ADDENDUM TO NSLPP REPORT PREPARED BY THOMAS HOLMAN

SUBJECT: 114 ATCHISON STREET, CROWS NEST

APPLICATION NO. 355/23 (LPP03)

This report should be read in conjunction with LPPO3 concerning DA355/23 for alterations and additions to a heritage listed dwelling including a two storey rear addition, alterations to an existing two storey 'Barn' outbuilding and landscaping works at 114 Atchison Street, Crows Nest.

Drawing
West Elevation No 116 Neighbour Shadows

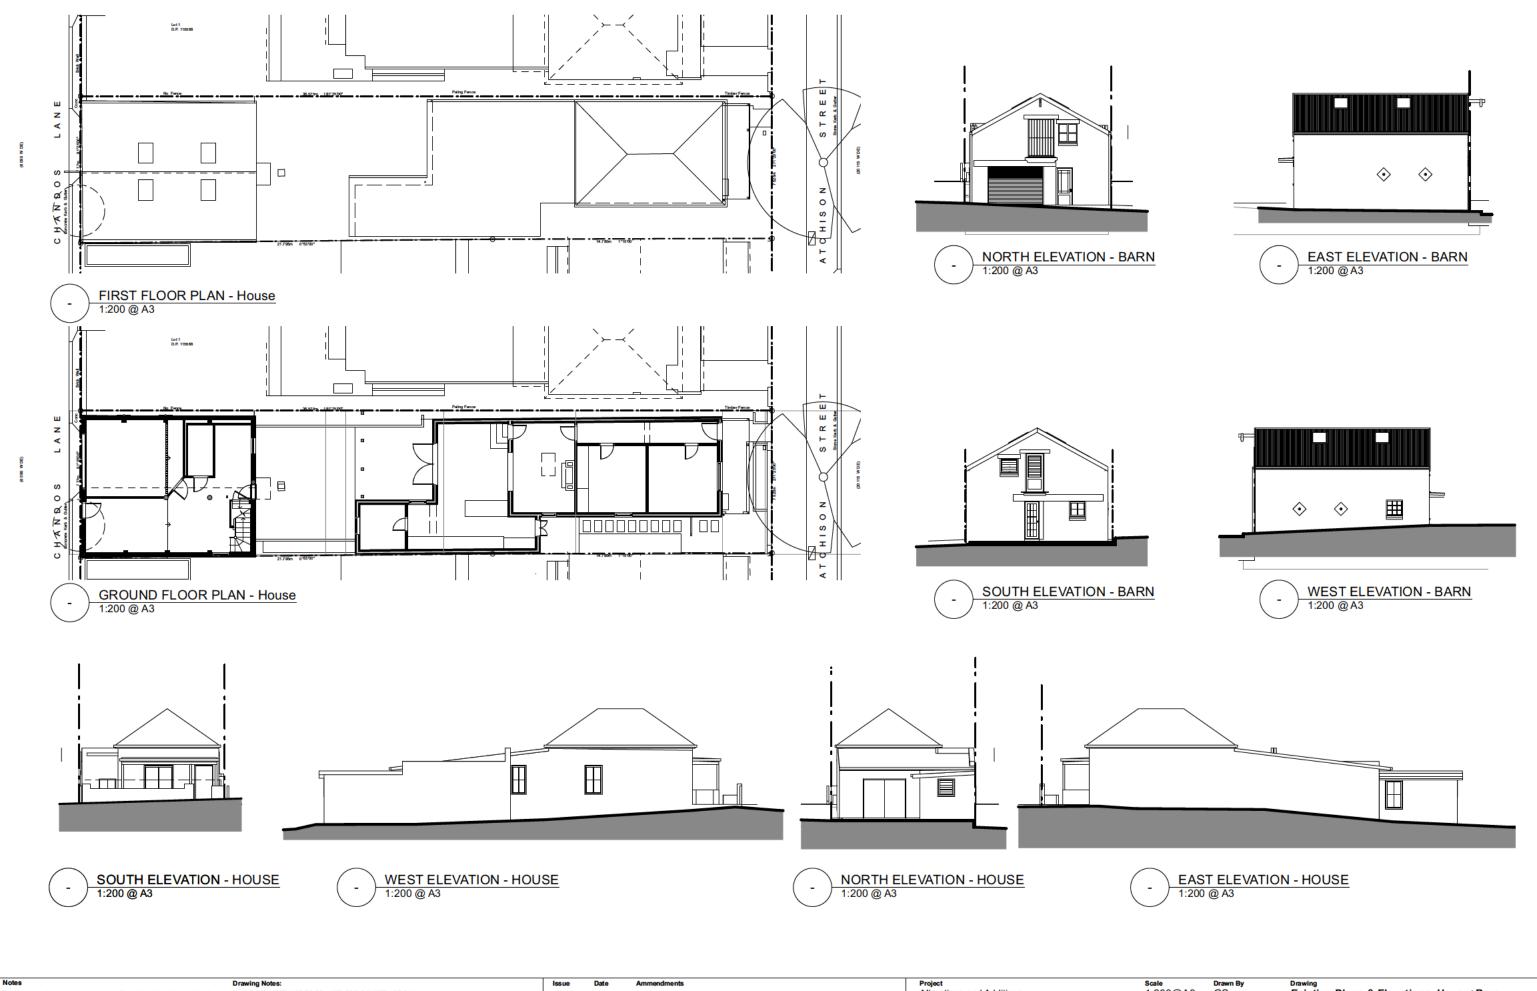
9AM-PROPOSED SHADOW MID WINTER 1:200 @ A3 NO CHANGE TO SHADOW

9AM-PROPOSED SHADOW EQUINOX 1:200 @ A3 NO CHANGE TO SHADOW

12PM-PROPOSED SHADOW MID WINTER 1:200 @ A3 NO CHANGE TO SHADOW

12PM-PROPOSED SHADOW EQUINOX 1:200 @ A3 NO CHANGE TO SHADOW

3PM-PROPOSED SHADOW MID WINTER 1:200 @ A3 ADDITIONAL SHADOW AS INDICATED NOTE: EXISTING FENCE & 3M HIGH **BOUNDARY SCREEN PLANTING** NOT PLOTTED.

3PM-PROPOSED SHADOW EQUINOX 1:200 @ A3 ADDITIONAL SHADOW AS INDICATED
